Quible & Associates, P.C.

March 27, 2024

Re: Major Site Plan Application Resubmittal
Athletic Facility – 1559 Waterlily Rd
Coinjock, Currituck County, North Carolina

A copy of the TRC review comments dated March 12, 2024 (McAdams) and March 13, 2024, are enclosed for reference, and our responses listed below for ease of review:

LANDSCAPING PLAN

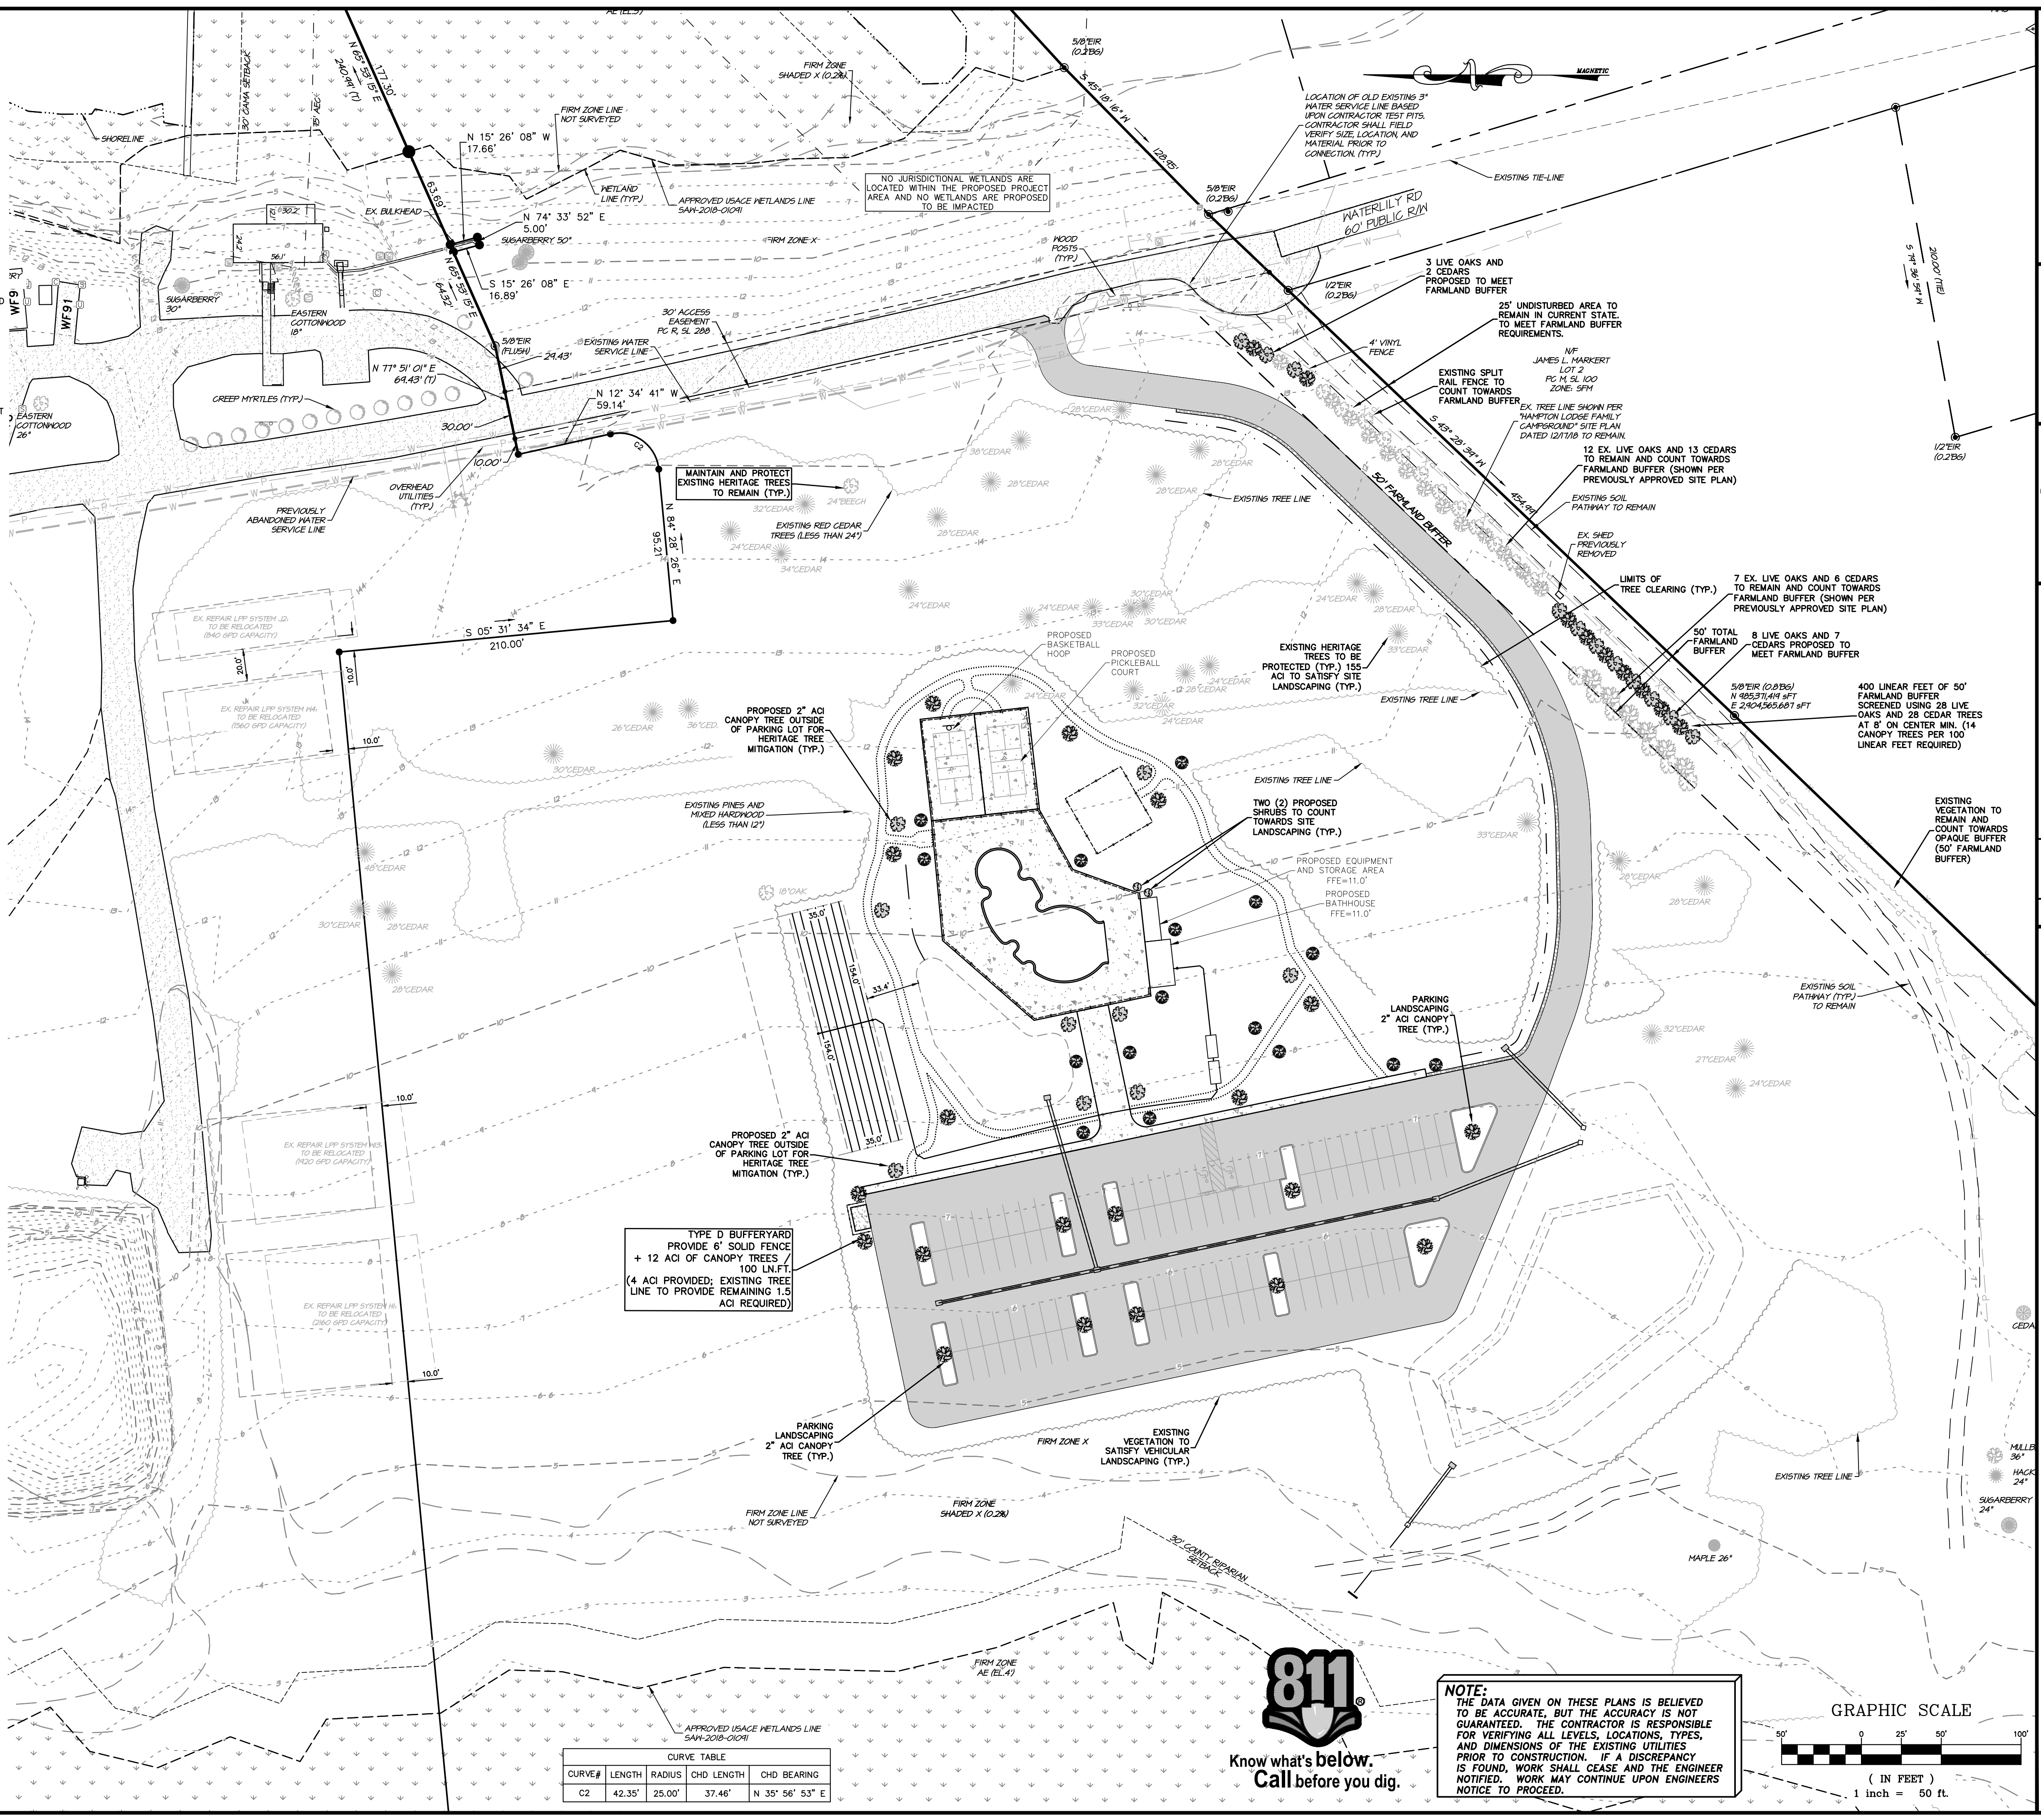
5. The proposed driveway needs to be removed from the 50' farmland buffer. Please reevaluate heritage tree impacts and submit a revised plan if needed. Ensure newly planted vegetation is not located in the 25' undisturbed portion of the farmland buffer. *Please see revised plan Sheet 3.*

Professional seal and title block for Quible & Associates, P.C. Includes project title 'SESC PLAN ATHLETIC FACILITY 1559 WATERLILLY RD', sheet number '5 OF 9 SHEETS', and date '12/12/23'.

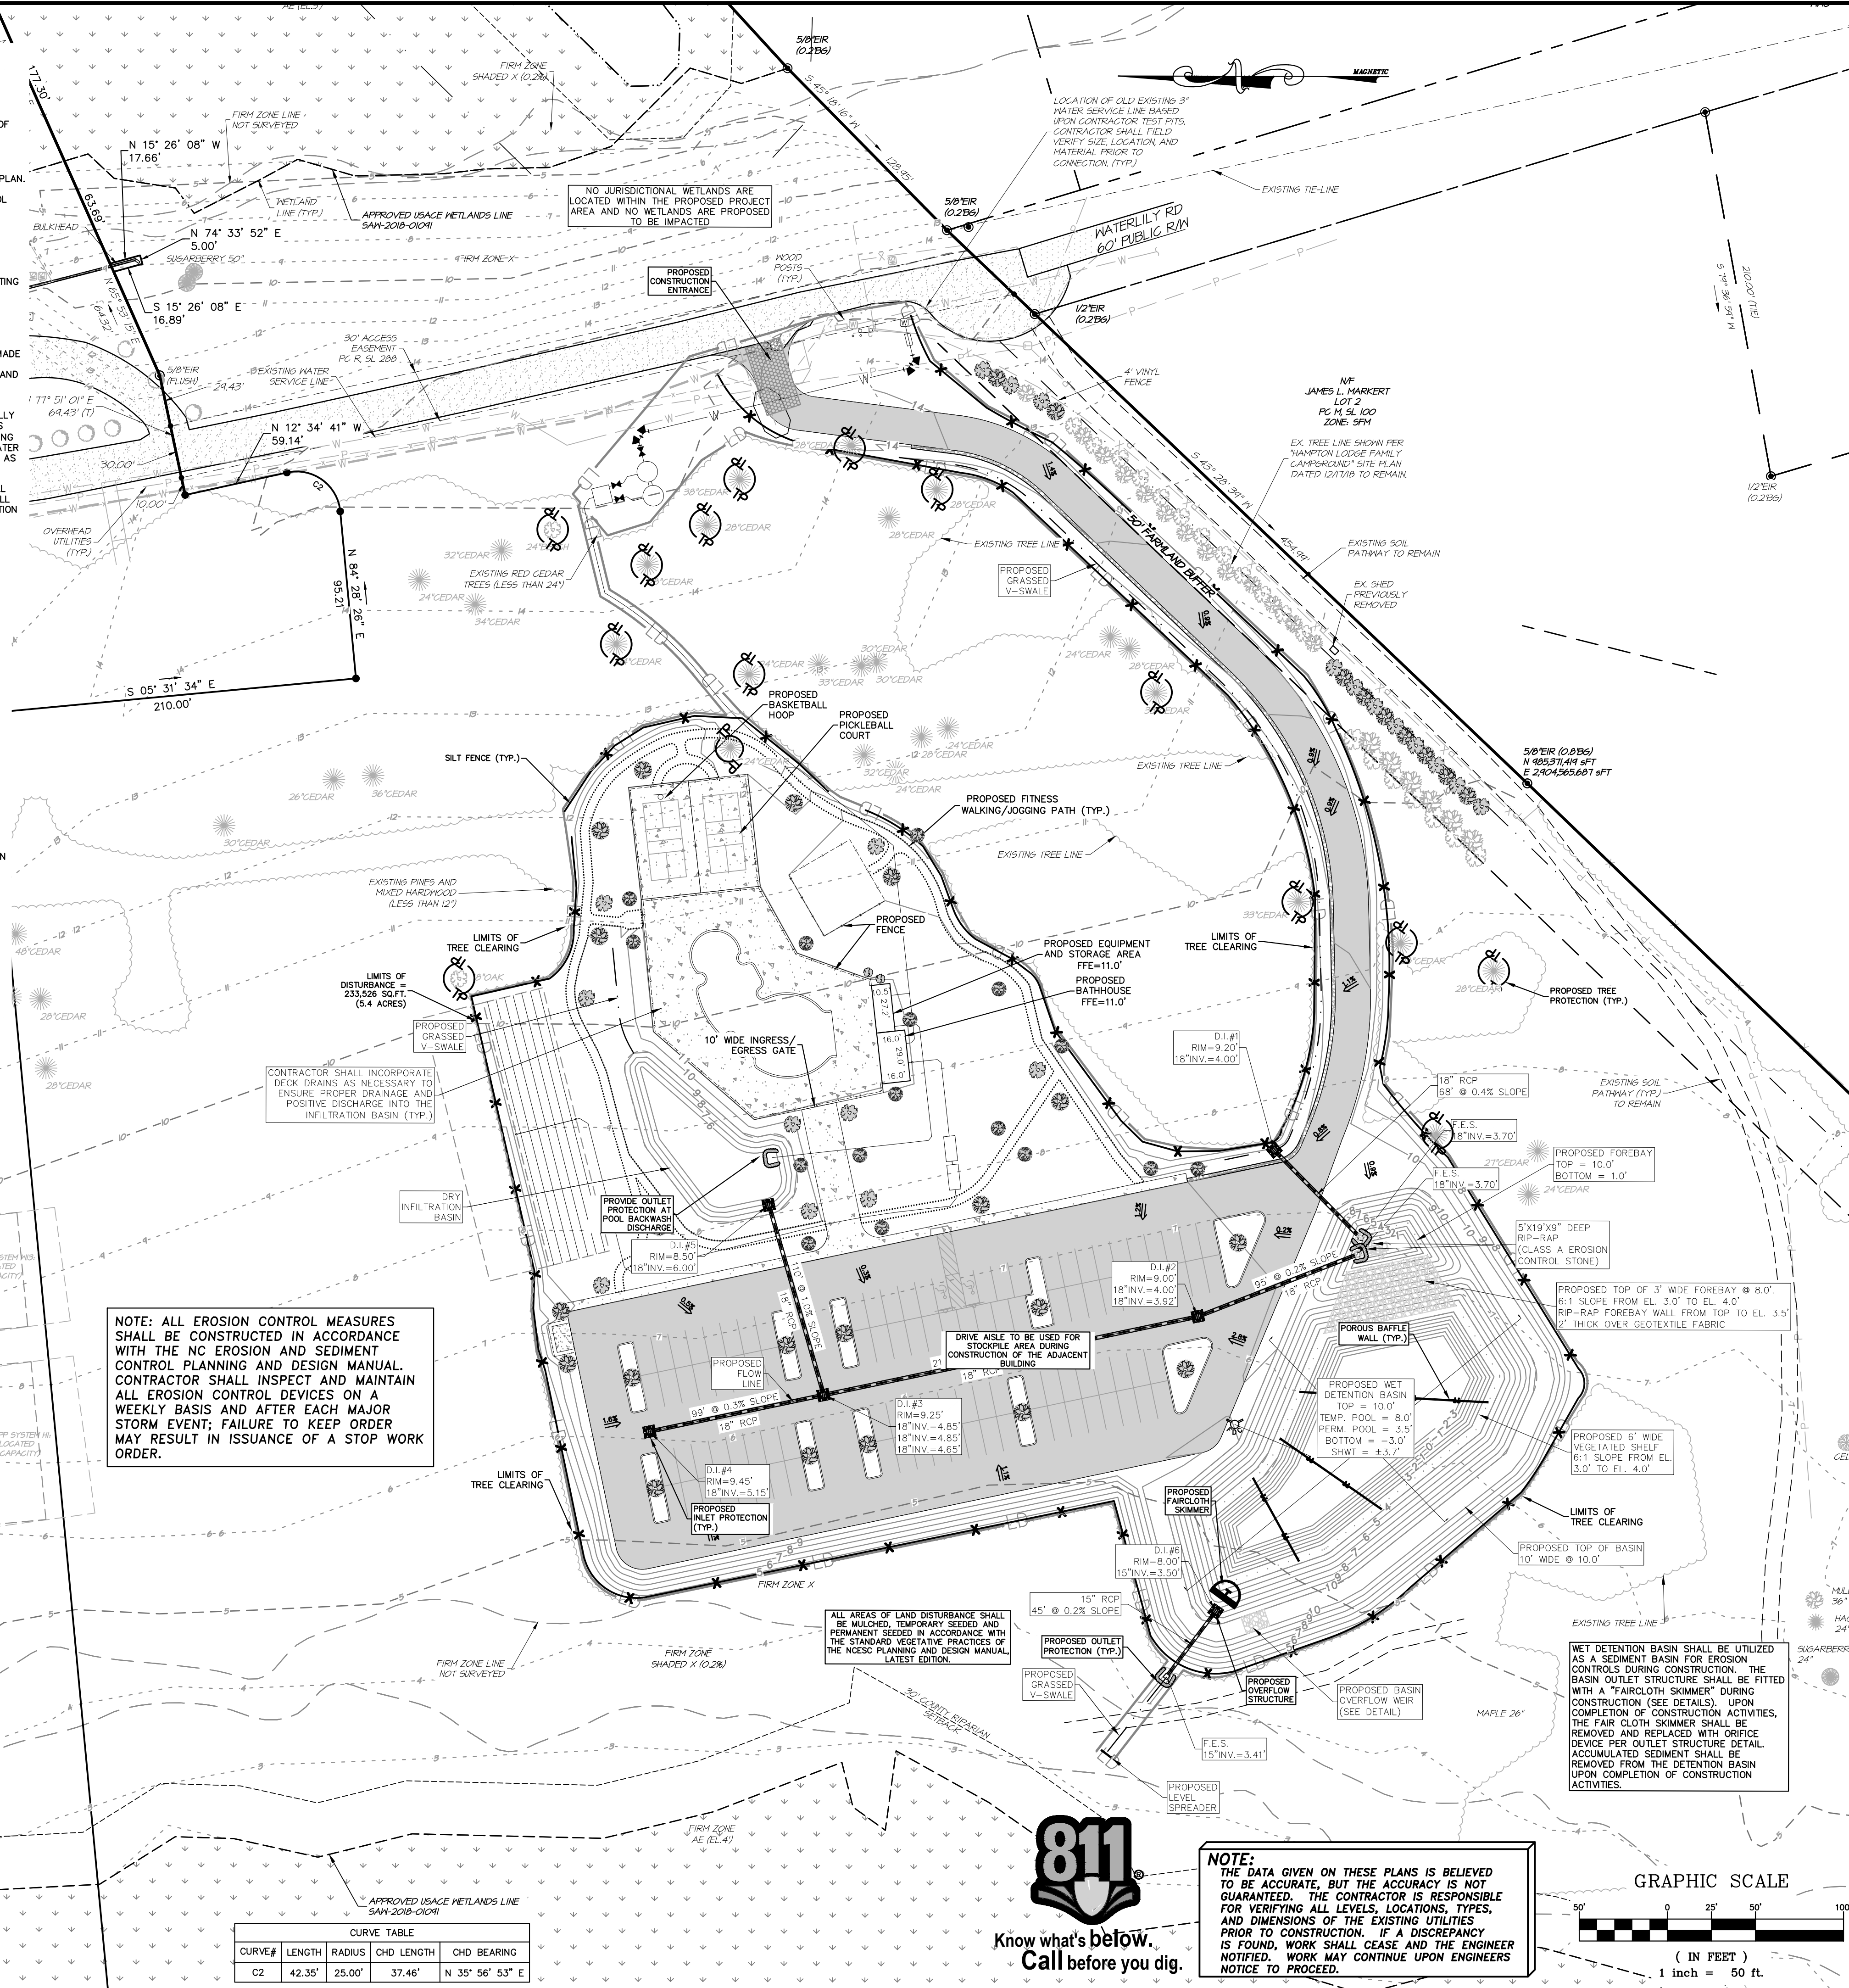
4. SESC Sheet #5 – Forebay berm elevation is defined at 8', which is the maximum stage storage elevation for the wet pond. The berm should allow for equalization of the forebay and main pool at the permanent pool elevation. *The forebay berm (top of rip-rap) has been set at elevation 8' (or temporary pool elevation). The intent is to maximize the forebay to settle out solids during all storms. The 8' (temporary pool elevation) up to 9.5' elevation will allow for equalization of the forebay and main pool during temporary storage. The design is set to allow for solids to settle out on within the forebay prior to discharge into the main pool and subsequent release downstream from the overflow structure. The design is not intended to equalize the permanent pool elevation as we feel that would not adequately settle out solids prior to discharge.*

5. SESC Sheet #5 – Upstream and downstream inverts of the outlet pipe in riser structure have a higher elevation than normal pool elevation than the listed normal pool elevation of 3.5'. The wet pond must have the ability to draw down to normal pool elevation. *Acknowledged. The inverts in plan view have been updated to match the outlet structure detail and a downstream swale is now shown.*
